SUBJECT: Grand Gulf Nuclear Station
Unit 1
Docket No. 50-416
File: 0272/L-860.0
Diesel Generator and Gas Turbine
Reliability
AECM-84/0241

RESPONSE TO NRC QUESTIONS ON
GAS TURBINE AND DIESEL GENERATOR RELIABILITY

DIVISION I LOSEP
DIESEL GENERATOR LOADING

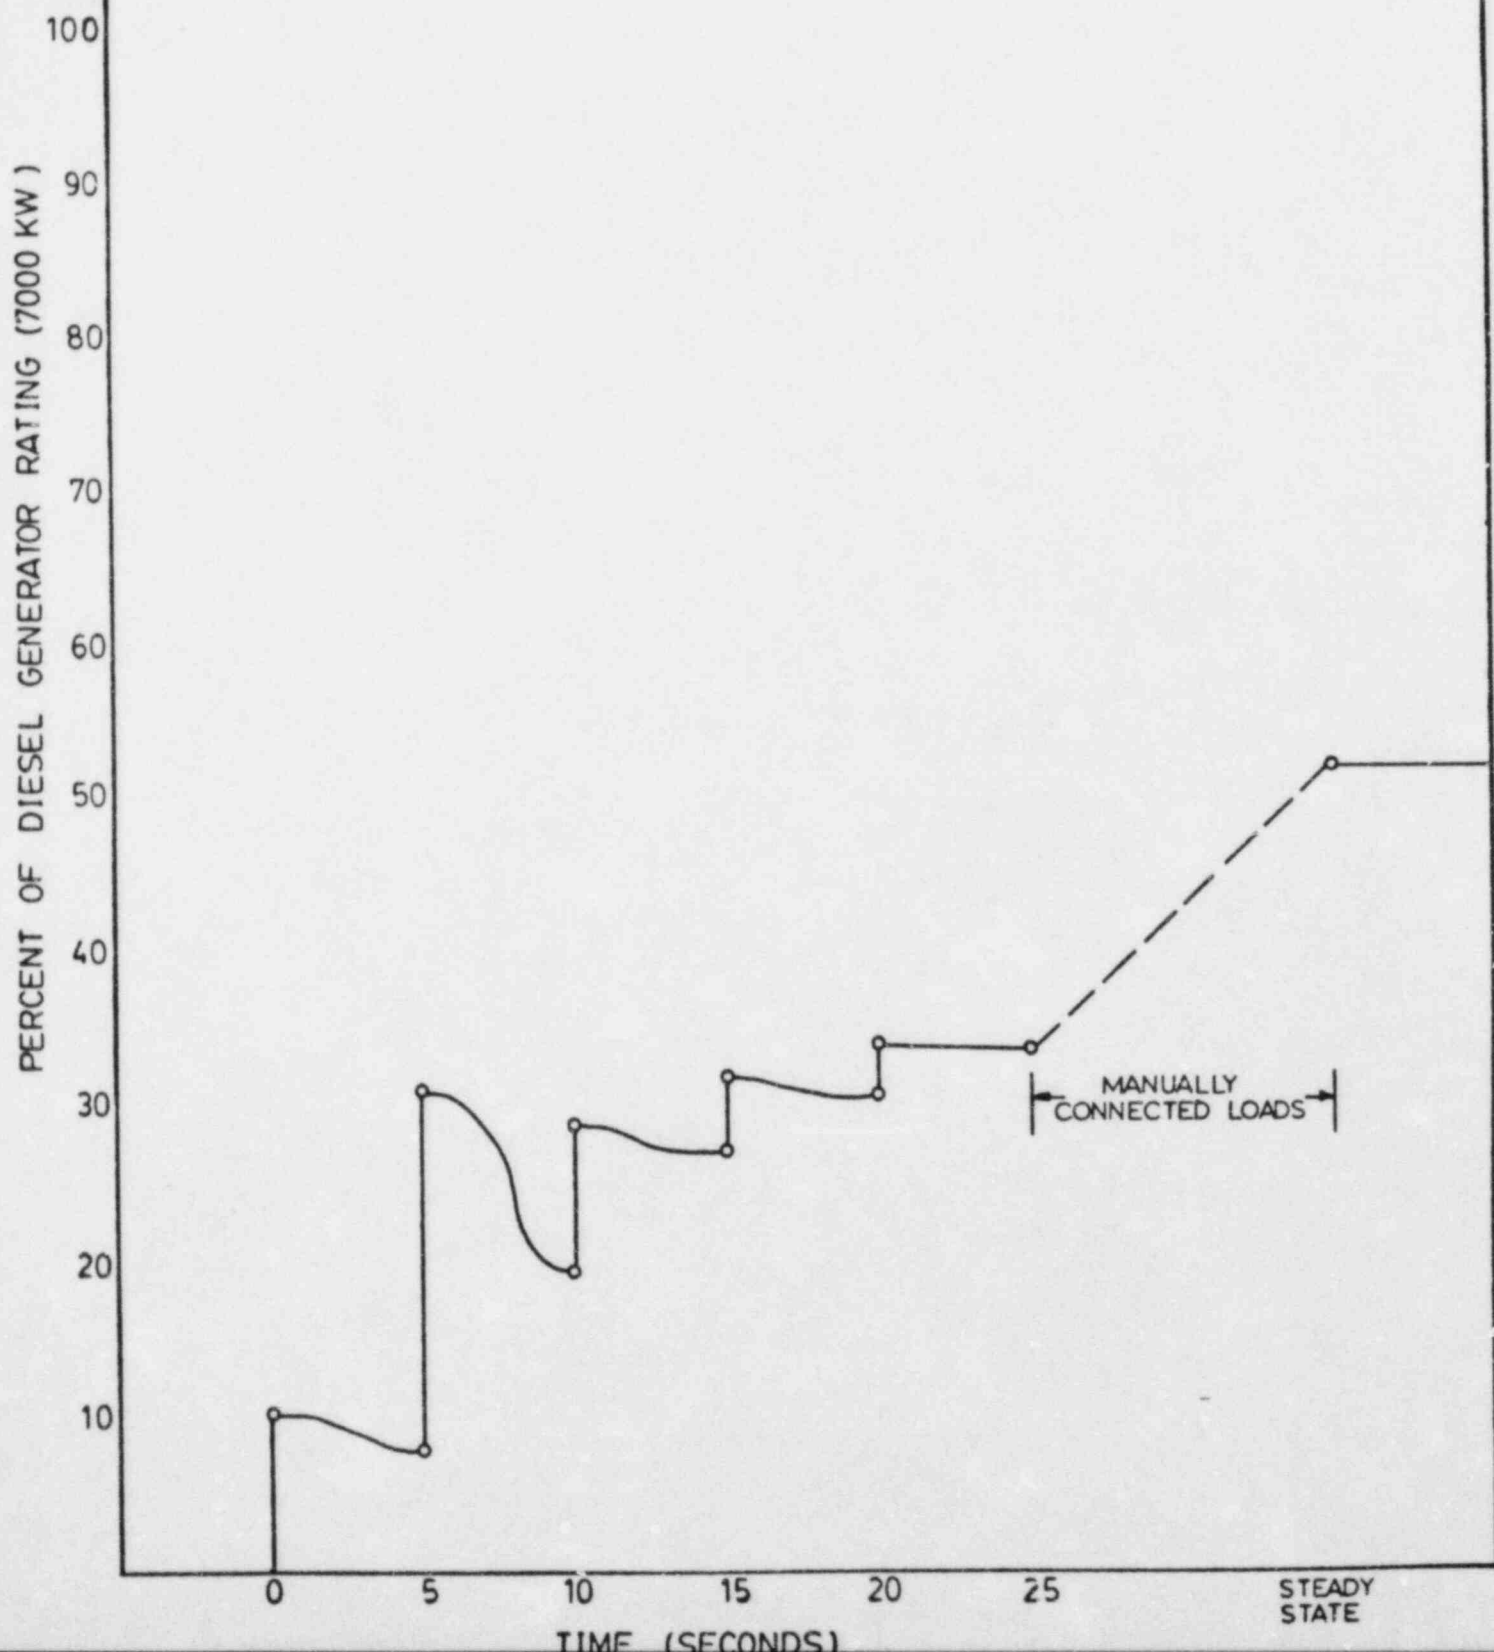
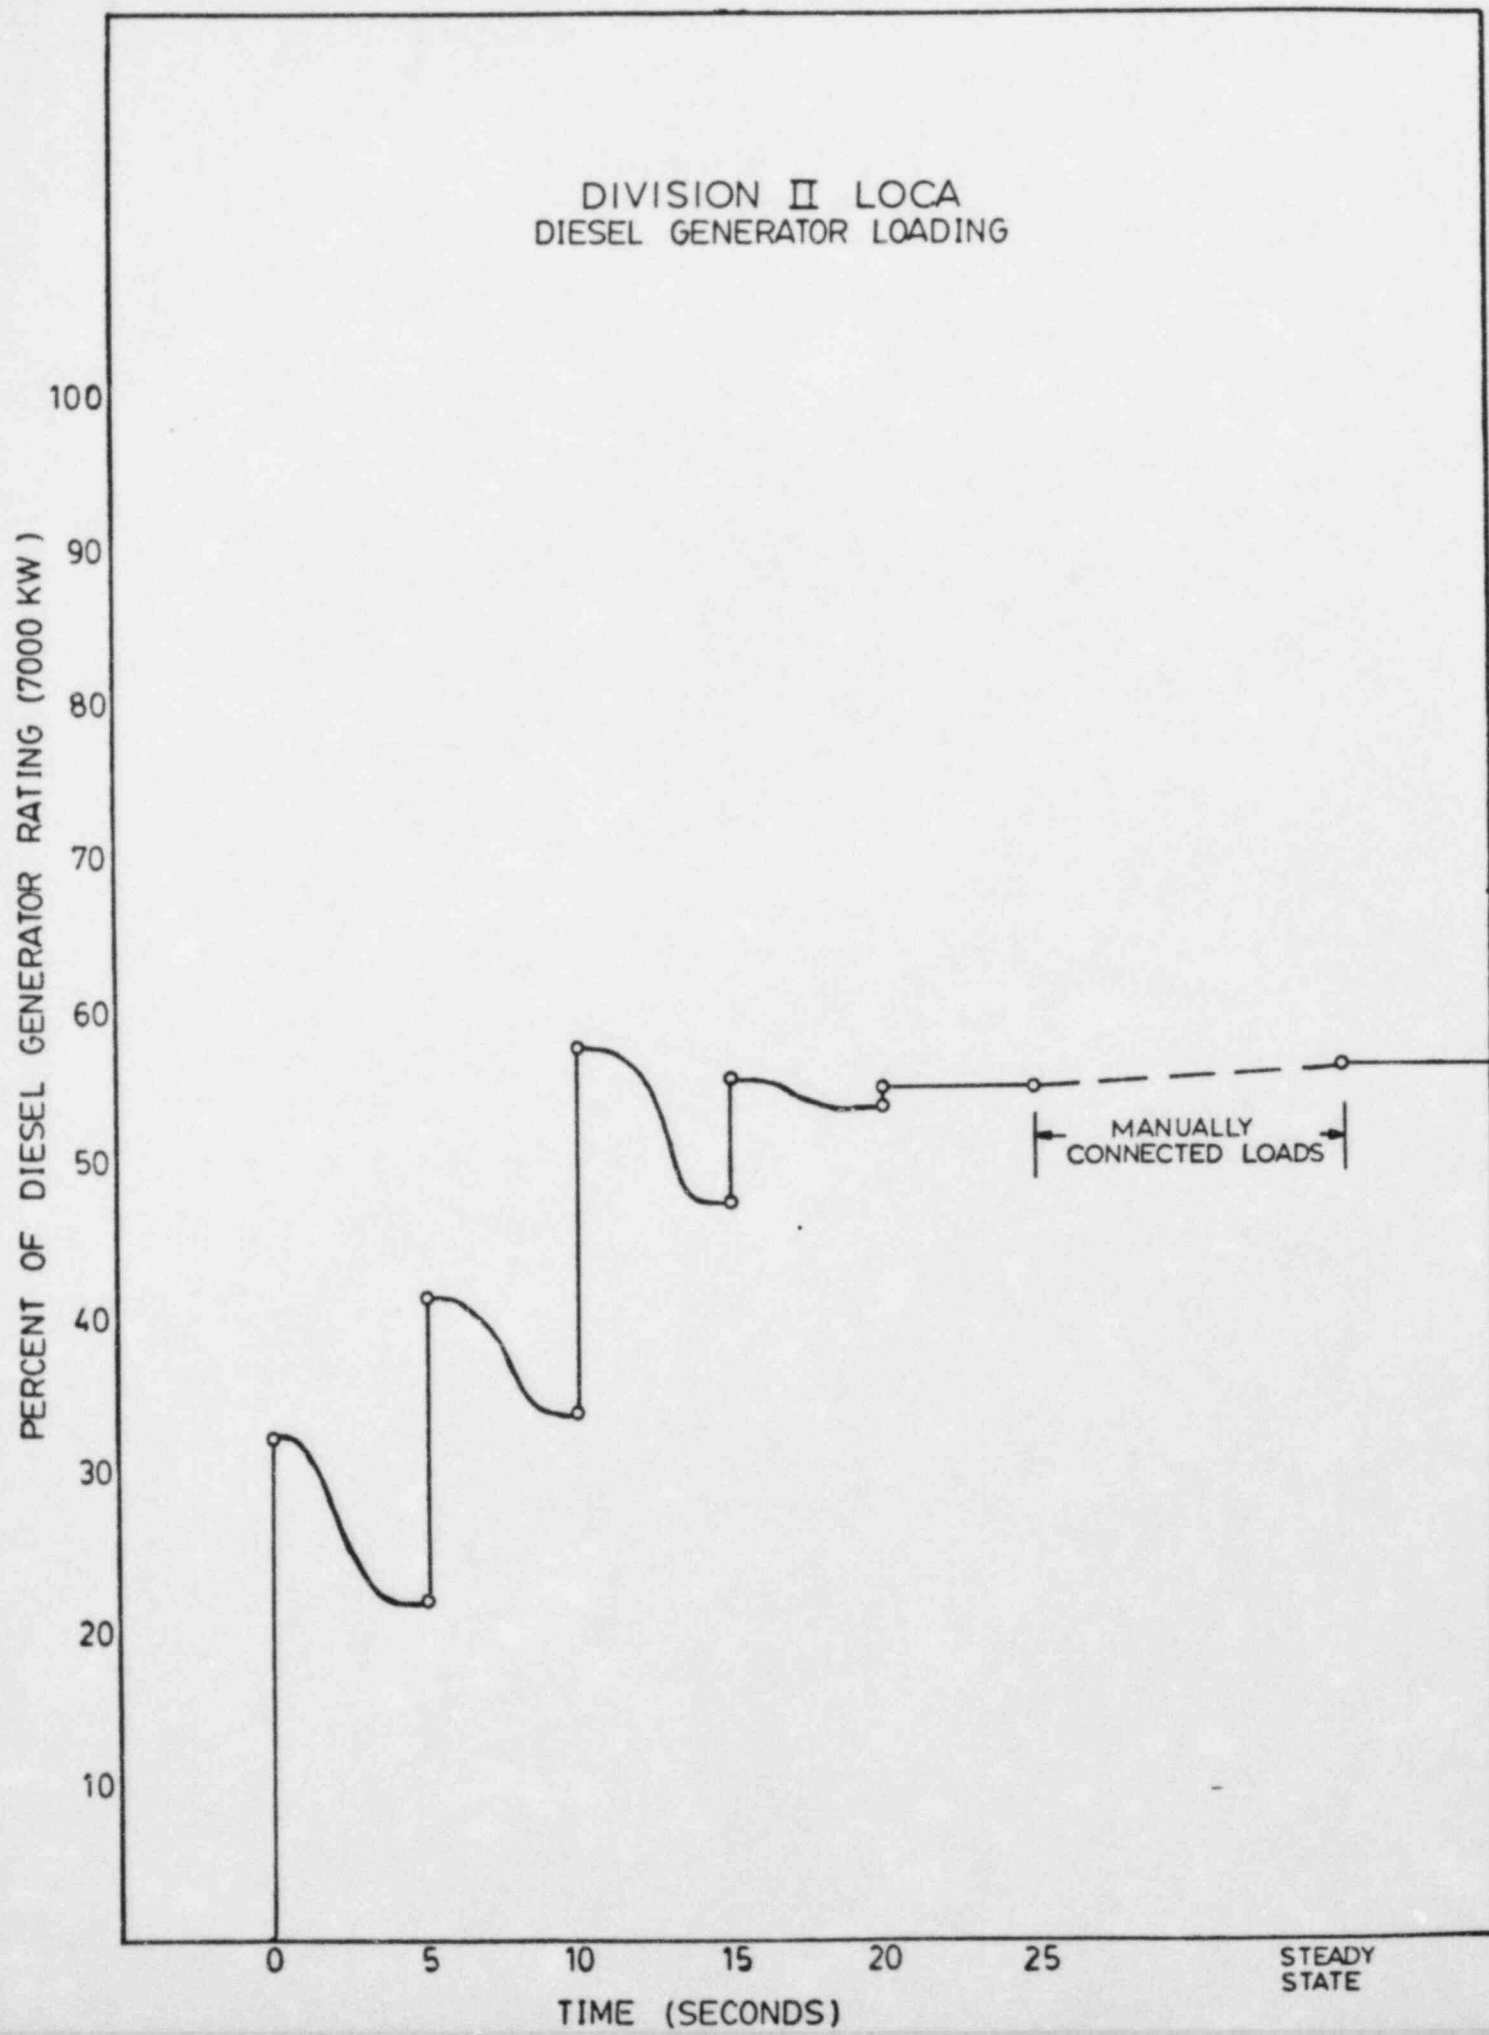
In the event of a loss of offsite power, are loads stripped from their buses? Provide the loads on the Division I and Division II ESF buses during post LOCA and loss of offsite power (LOSP) conditions.

Attachment 2 provides Division I and Division II LOCA and LOSP loading curves and a listing of the different loads that are required for each condition.

For Division I, the load required during LOCA is roughly 1,000 KW higher than that of a LOSP. This is due largely to the 2,000 HP LPCS pump which is required only for LOCA.

LOAD GROUPS FOR GAS TURBINE GENERATORS (3 UNITS)

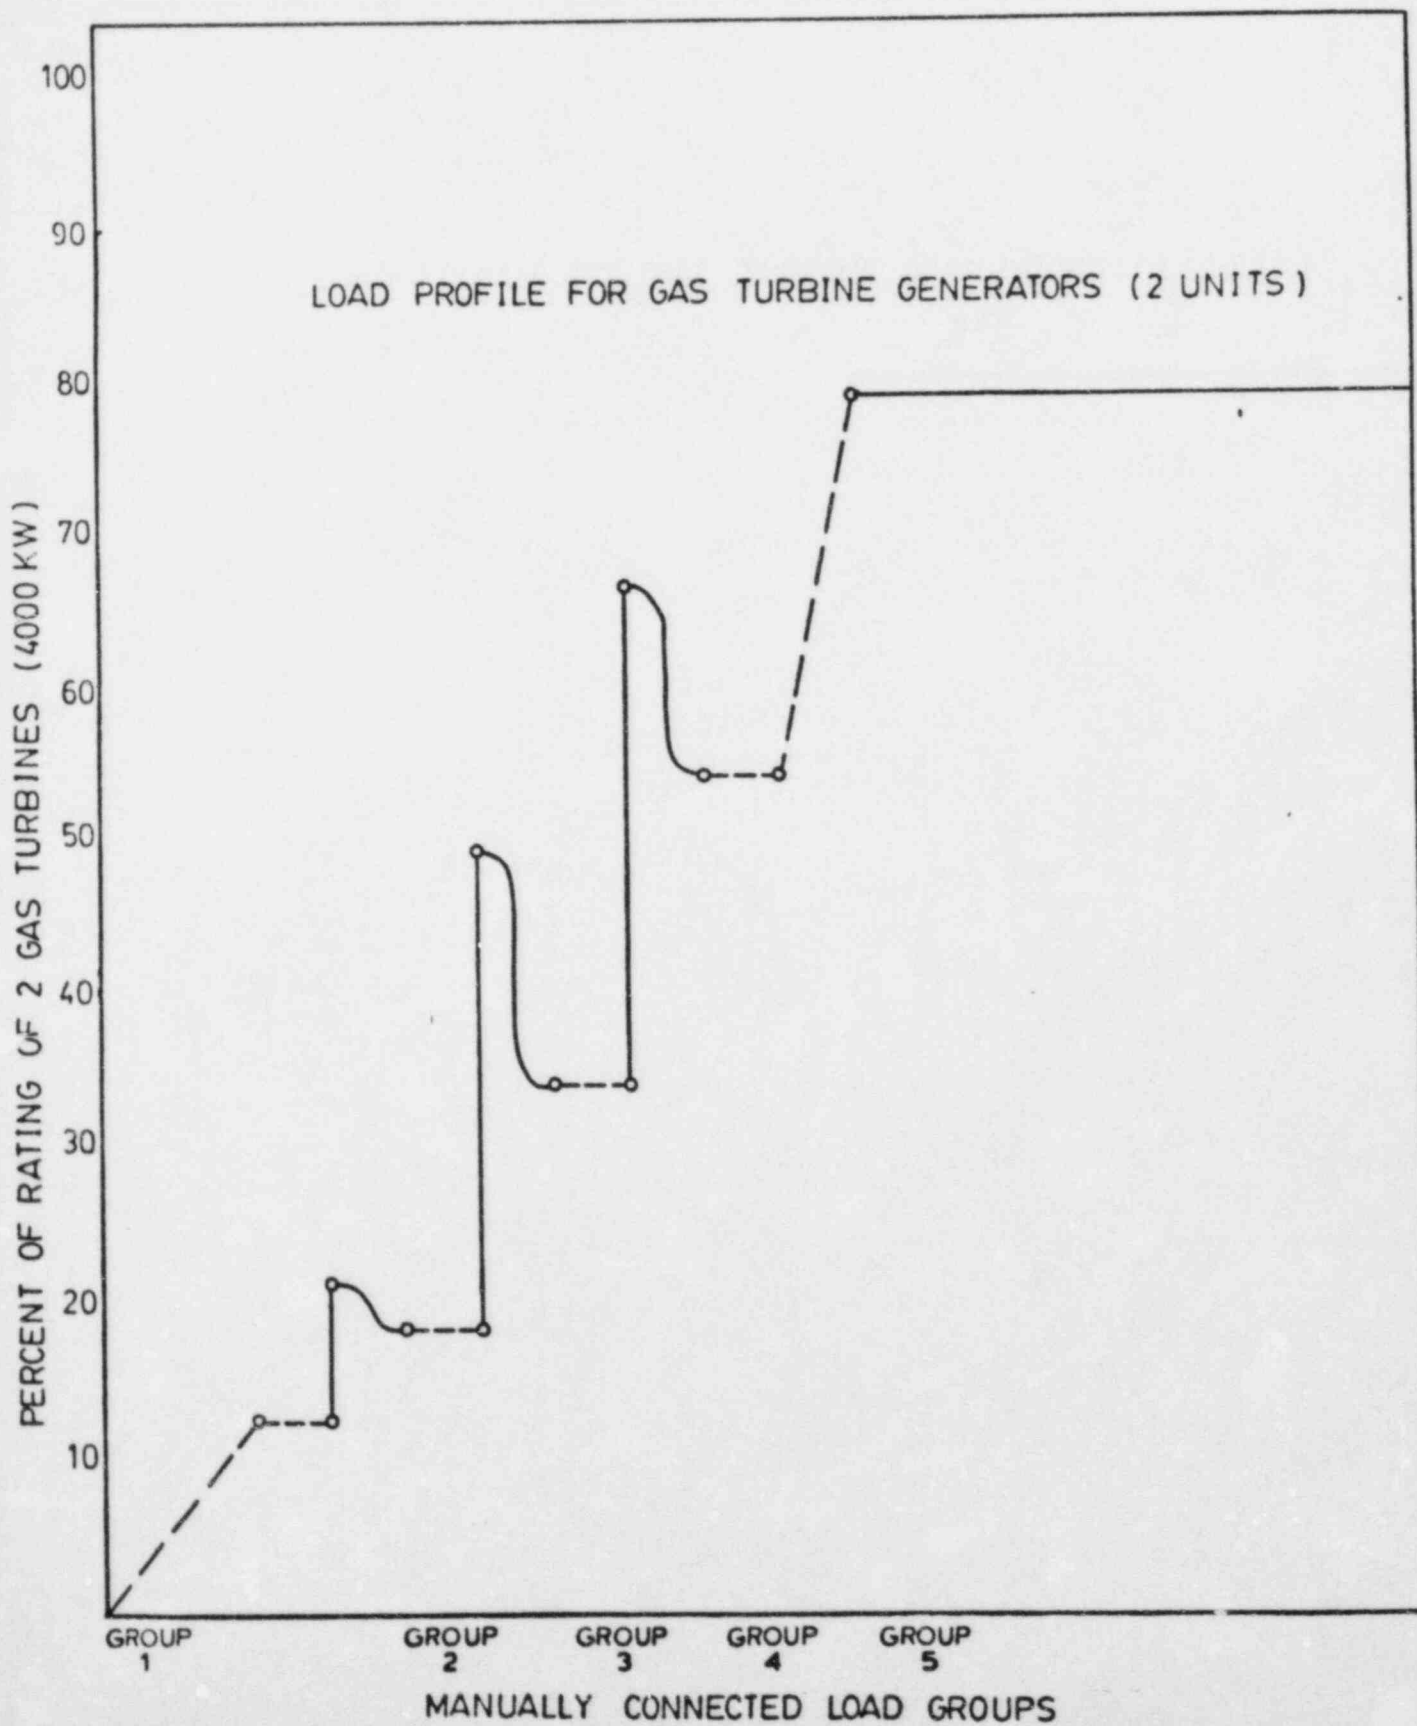
Provide the loading on the gas turbine generators during station blackout conditions.

Attachment 3 provides anticipated gas turbine generator loading curves and a listing of loads during station blackout conditions for both three gas turbine generator unit and two gas turbine generator unit operation.

Figure 1

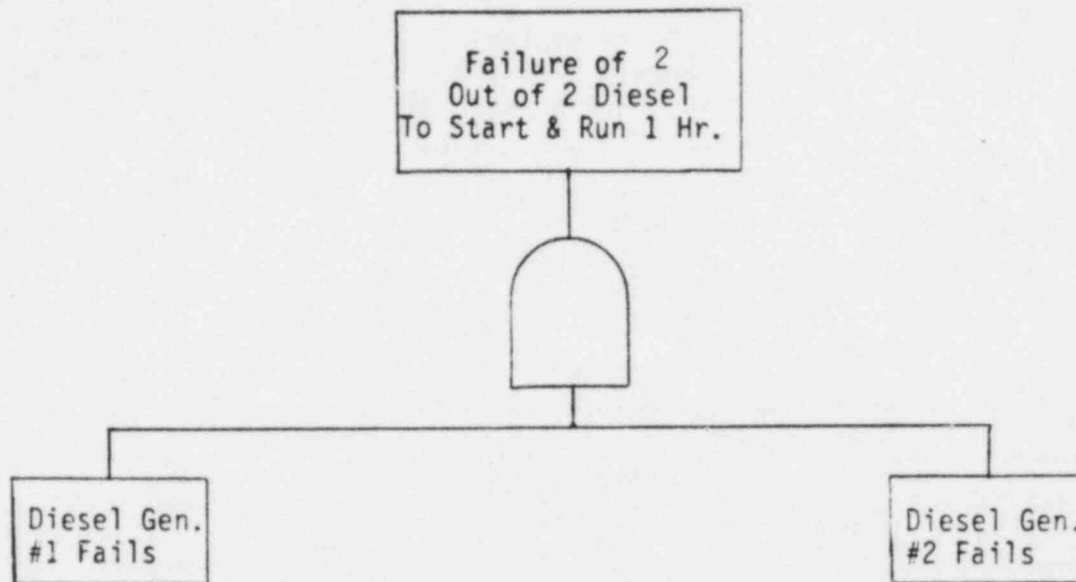
Provide a reliability evaluation of the extent to which the gas turbine generators can offset a postulated degradation in the reliability of the TDI diesel generators.

The more probable LOSP event will be used to examine to what extent the gas turbines can offset a degradation in diesel generator reliability. Figure 1 represents a simple fault tree representation of the on-site AC power system if only Division I and II diesel generators were available. The top event is defined as failure of two out of two diesel generators (DG) to start and run for an hour (Note: One hour is consistent with testing requirements in Reg. Guide 1.108. Also, as used in this evaluation, the one hour duration is more conservative than a more encompassing four hour duration.). Based on Reference 6.5, the generic failure probability for a DG to start and run for one hour is .033 per demand. Therefore, using the Boolean expression for the fault tree logic represented in Figure 1, a conservative goal probability for the loss of on-site power (LOP) is:

$$P(\text{LOP}) = P(\text{DG1})P(\text{DG2}) \quad (2)$$

$$P(\text{LOP}) = (.033)^2 = 1 \times 10^{-3} \text{ per demand}$$
